STAFF REPORT:	C.U.P. 22-31 Ashton Meadows - Preliminary and Final Plat
HEARING DATE:	August 11, 2022
TO:	Planning and Zoning Commission
STAFF:	Cynda Herrick, AICP, CFM Planning and Zoning Director
APPLICANT/ PROPERTY OWNER:	Charles H Silzly 267 W River Meadow DR Eagle ID 83616
REPRESENTATIVE:	Heidi Schneider 291 Ashton Lane McCall, ID 83638
SURVEYOR:	Chip Bowers Bowers Land Surveys, Inc. PO Box 976 Cascade, ID 83611
LOCATION:	295 Ashton Lane Part of parcel RP17N04E073755 NW ¼ Section 7, T.17N, R.4E, Boise Meridian, Valley County, Idaho
SIZE:	7.65 acres
REQUEST:	Single-Family Residential Subdivision
EXISTING LAND USE:	Single-Family Residential Rural Parcel and Agricultural (Grazing)

ASHTON SUBDIVISION

RE: Final Plat Review "Ashton Subdivision"

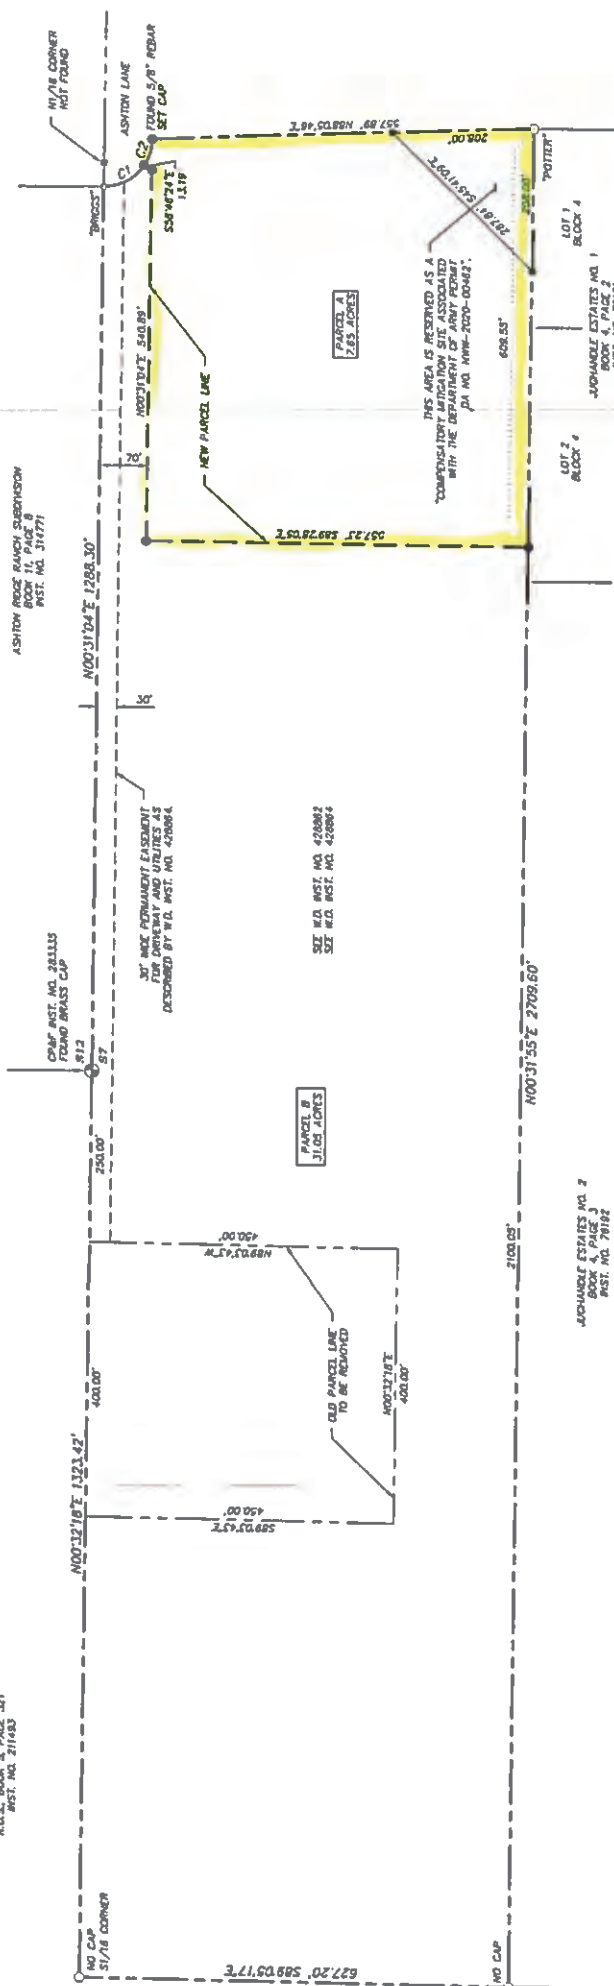
Both subdivision sheets are labeled Sheet 1 of 1. They should be labeled Sheet 1 of 2 and Sheet 2 of 2.

7. All easements shall be shown on the final plat.
8. The area shown on the final plat as "compensatory mitigation site" shall be labeled as a "No Build Area".

9. Must place a base flood elevation on the face of the plat.
10. Shall place addressing numbers at the residence and at the driveway entrance if the house numbers are not visible from the road.
